UNITED STATES PATENT AND TRADEMARK OFFICE

APPLICATION NO.	FILING DATE	FIRST NAMED INVENTOR	ATTORNEY DOCKET NO.	CONFIRMATION NO.
09/986,241	10/22/2001	Kenneth A. Stewart	CS11493	4998

Office Action Summary

DETAILED ACTION

Fig. 5

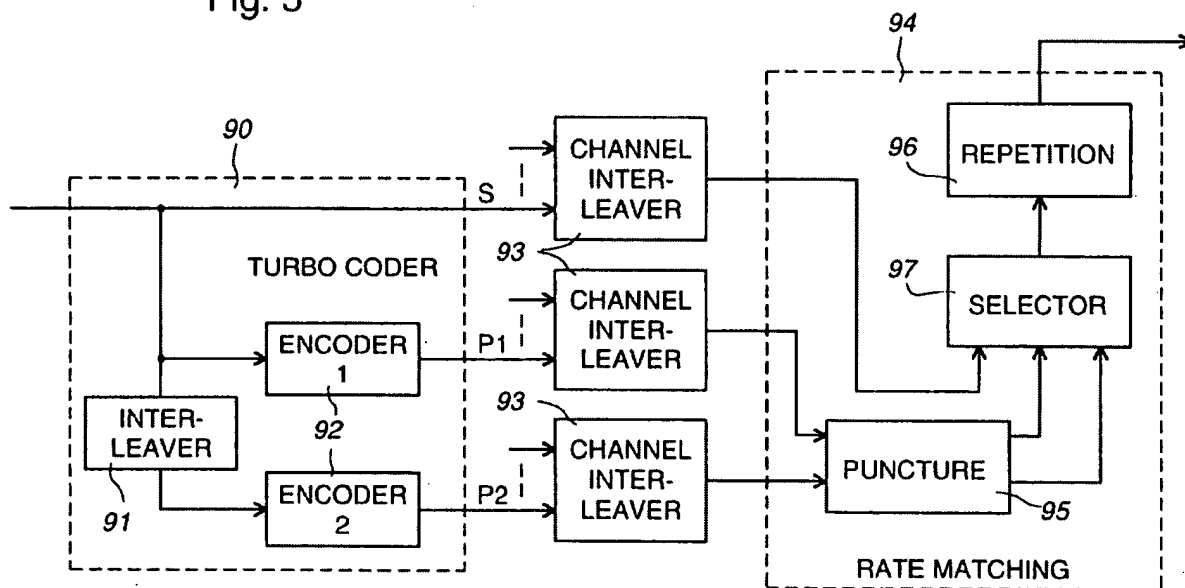
Applicant contends, "...Yamaguchi (prior art of record) fails to disclose selecting a predefined redundancy..." The Examiner respectfully disagrees. The prior of are record, Tong teaches (Figure 5) a rate matching scheme wherein data bits in a matrix are interleaved by a predetermined interleaving process, to a desired rate by deletion of redundant data bits or repetition of data bits derived from the matrix. It includes steps of determining in a non-

interleaved matrix of the data bits a pattern of bits to be deleted or repeated to provide the desired data rate, decoding an address of each bit in said pattern in a manner inverse to the interleaving process to product a respective address of the bit in the matrix of interleaved data bits, and deleting or repeating the respective bit in the interleaved data bits in dependence upon the respective address. The address decoding is performed in the same manner as a coding of addresses for producing the interleaved data bits from the non-interleaved matrix of the data bits. The Examiner would like to point out that an encoder normally attaches a predefined amount of redundancy to data prior to transmission.
